1R 482
Gen. Cor.
2007

Re: Penrose Federal Lease Battery #1, Unit F, Section 9, Township 22S,
Range 37E, Lea County, New Mexico
OCD Case #1R0482

Re: 1R0482, Response Monitoring Well Installation Request, John H. Hendrix Corporation, Penrose Federal Lease, Battery #1 Unlined Surface Impoundment (Closed), Unit F (SE/4, NW/4), Section 9, Township 22 South, Range 37 East, Lea County, New Mexico

FIGURE #2

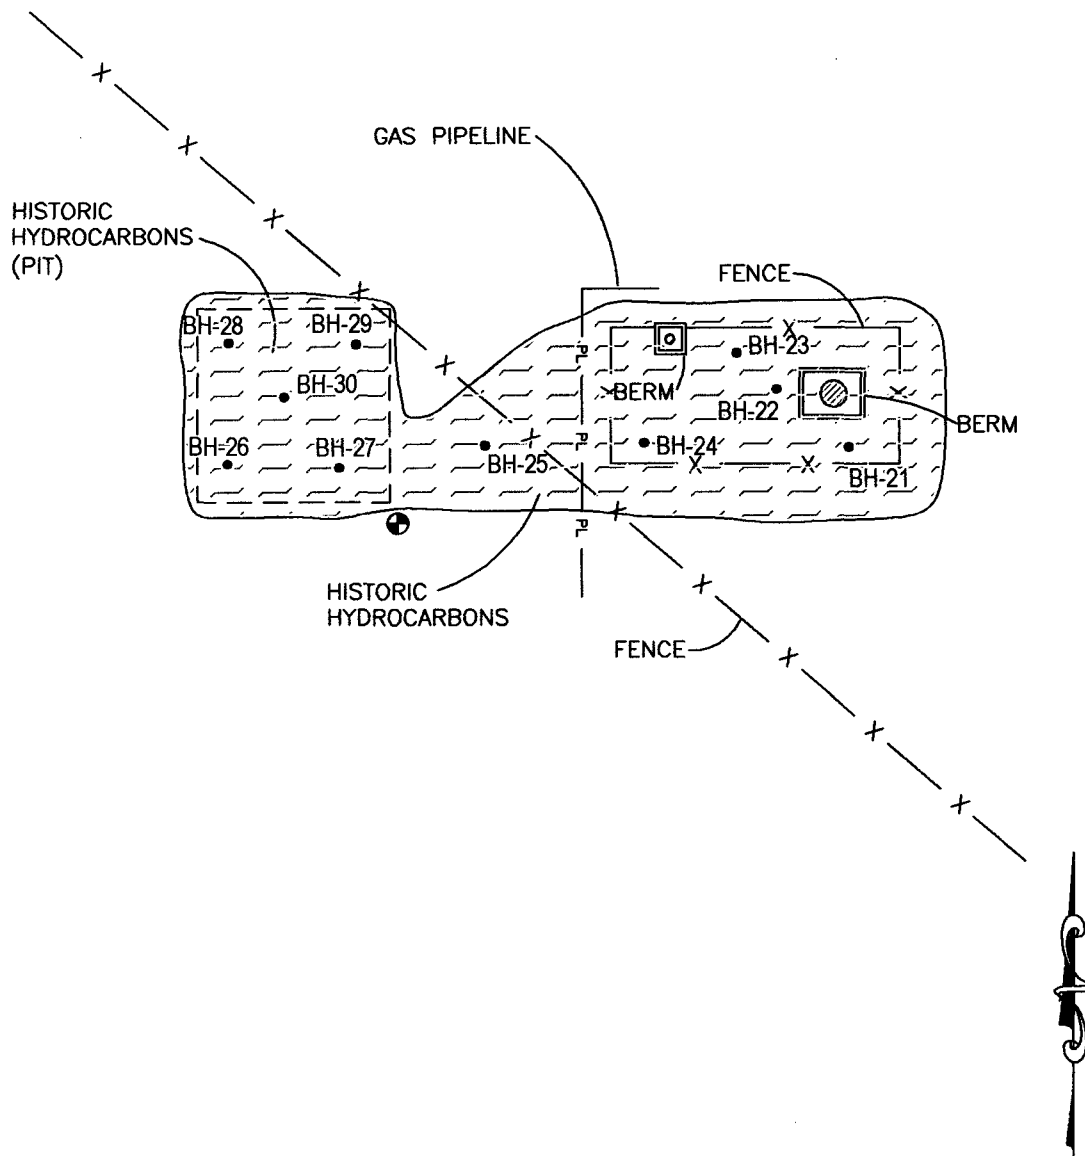
The results of laboratory analysis of soil samples from boring BH-30 indicate that chloride has migrated vertically and may have encountered ground water. Installing a monitoring well in the pit poses a significant risk for cross-contamination of ground water from contaminated soil. Therefore, JHHC should install a monitoring well according to OCD guidelines and USEPA recommended practices. The well should be installed adjacent (within 25 feet) and hydrologically down gradient (southeast) of the pit. Figure 2 presents a Site drawing and proposed monitoring well location.

1R0482 Penrose Federal - OCD is in receipt of the January 09 and May 10, 2007 documents and pursuant to our discussions on August 29, 2007 hereby approves installation of the monitor well in close proximity to the pit and approves the proposed remediation plan. Please include this E-mail notice in the final closure report.
